Baseline Monitoring Report

Anderson Farm Mitigation Site

Wayne County, NC
NCDEQ Contract No. 0402-10
DMS ID No. 100180
DWR No. 2021-0023v2

Subject: Draft MYO Report Review
Anderson Farm Mitigation Site, Wayne County
Neuse River Basin: 03020201
DMS Project ID No. 100180
DEQ Contract # 0402-10

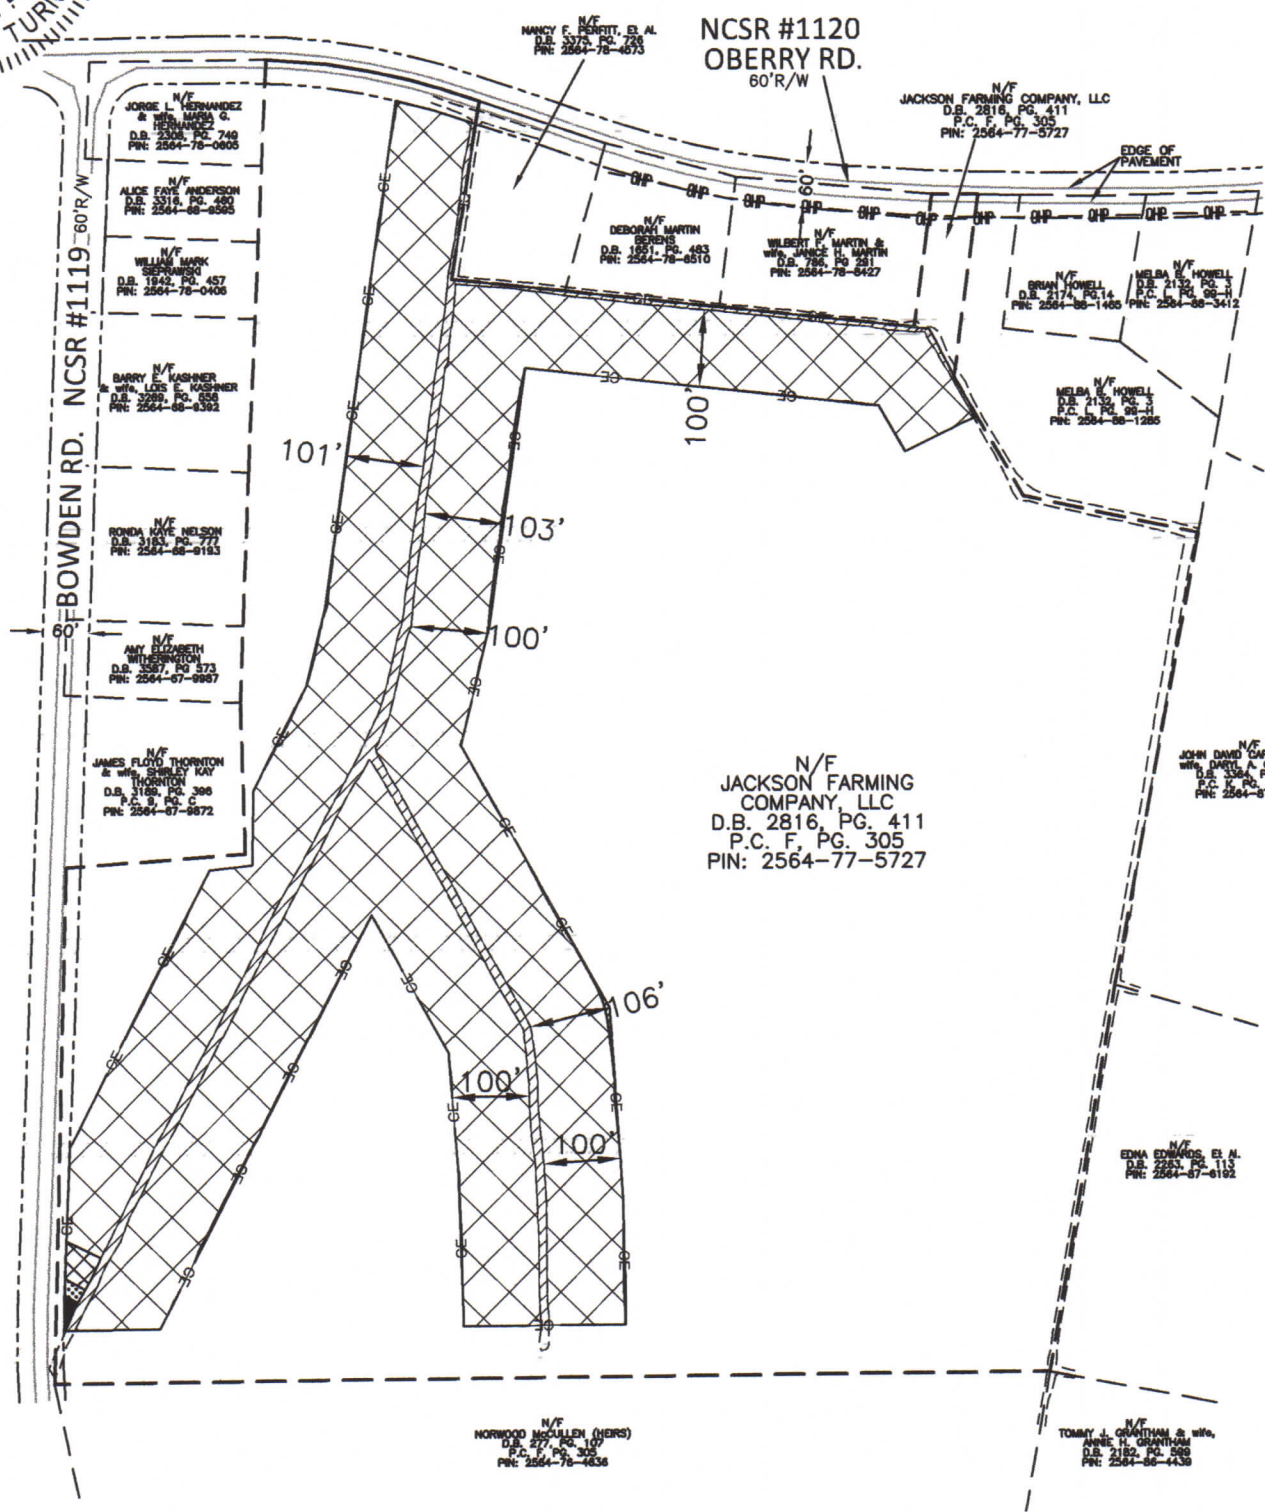
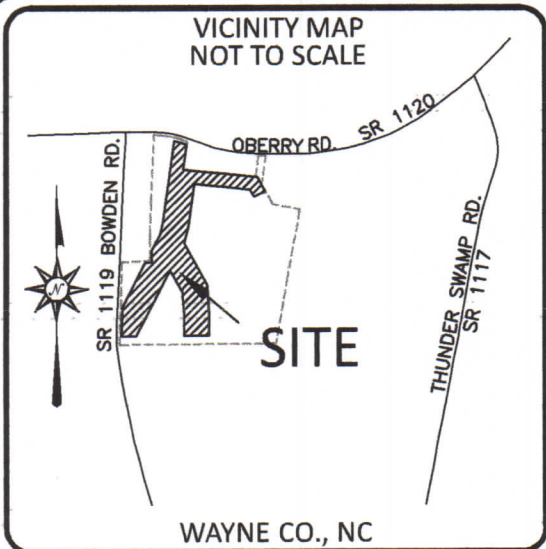
Appendix 3 – This seems to be the as-built survey. Typically, the record drawing is the as-built survey over-laying on the proposed design. Please make necessary change.

Response: The correction has been made. The document in Appendix 3 is now referred to as "As-Built Survey".
